CITY OF PORTLAND

PERMIT

Permit Number: 090400

This is to certify that J J & K MANAGEMENT LLC John Mur
has permission to Install 4/12 Truss Roof on Existing Structure 6ft. Ice Water Shed-Bottom Edge, 3ft. Up the Side.
AT 1269 WASHINGTON AVE CE 402 C001001

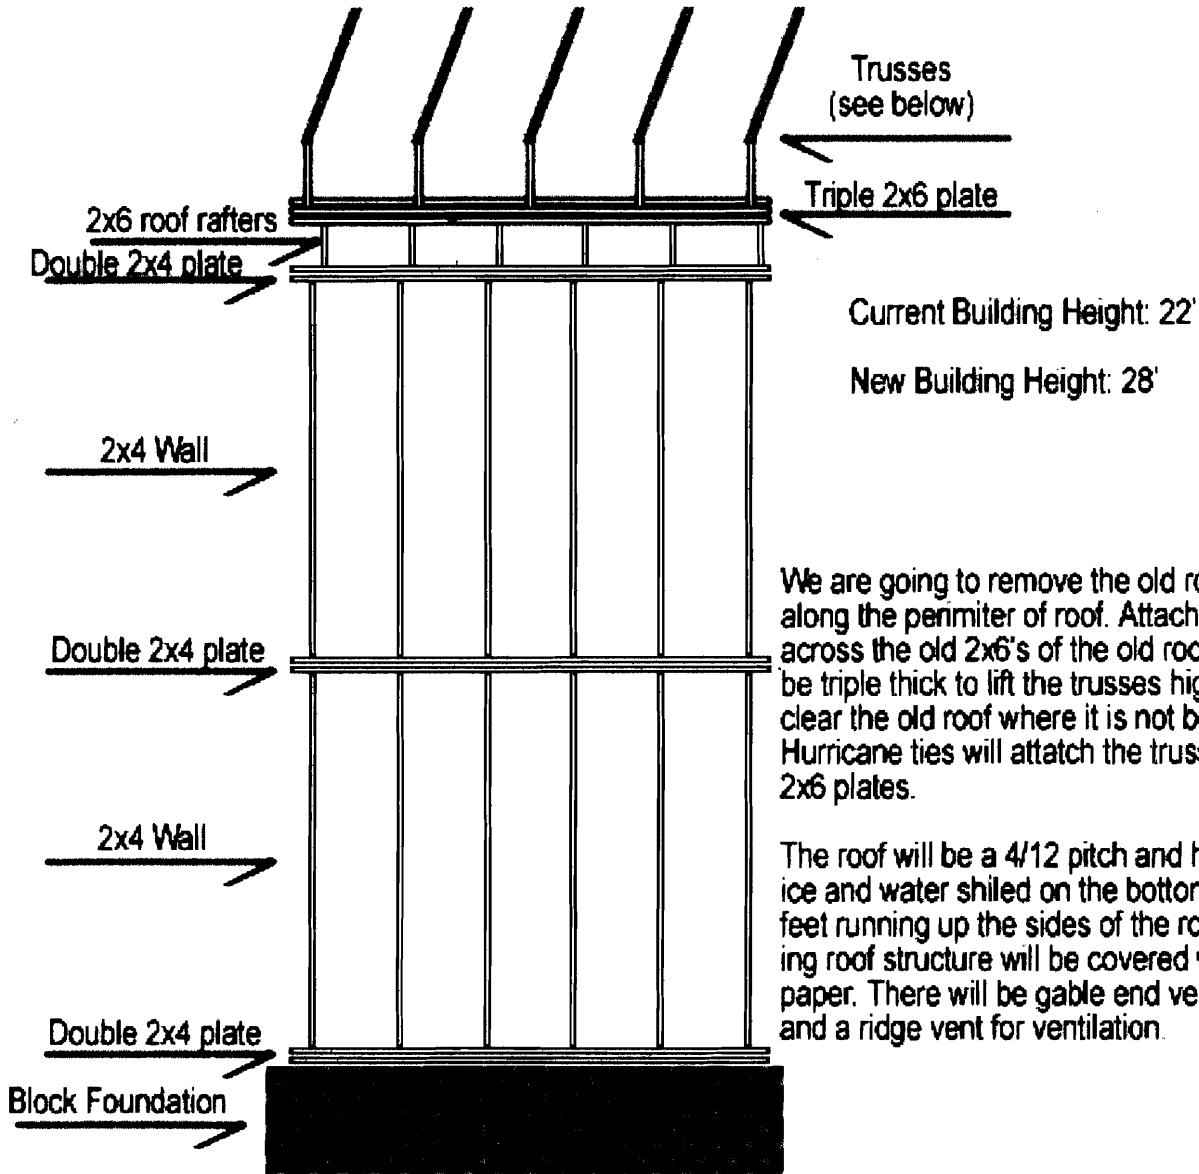
We are going to remove the old roof and decking along the perimeter of roof. Attach 2x6 plates flat across the old 2x6's of the old roof. The 2x6's will be triple thick to lift the trusses high enough to clear the old roof where it is not being removed. Hurricane ties will attach the trusses to the new 2x6 plates.

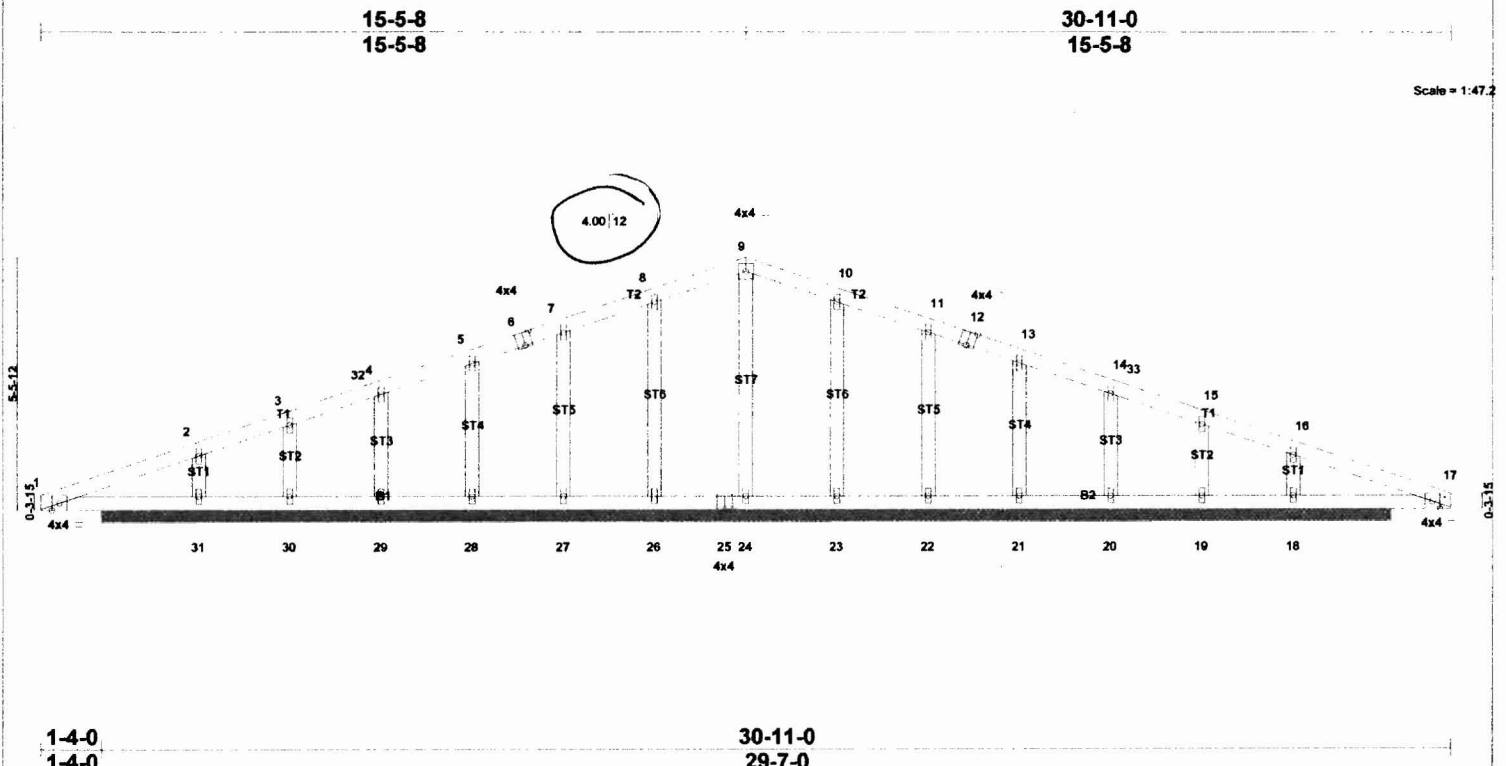
has bbe
4/12

has bbe
4/12
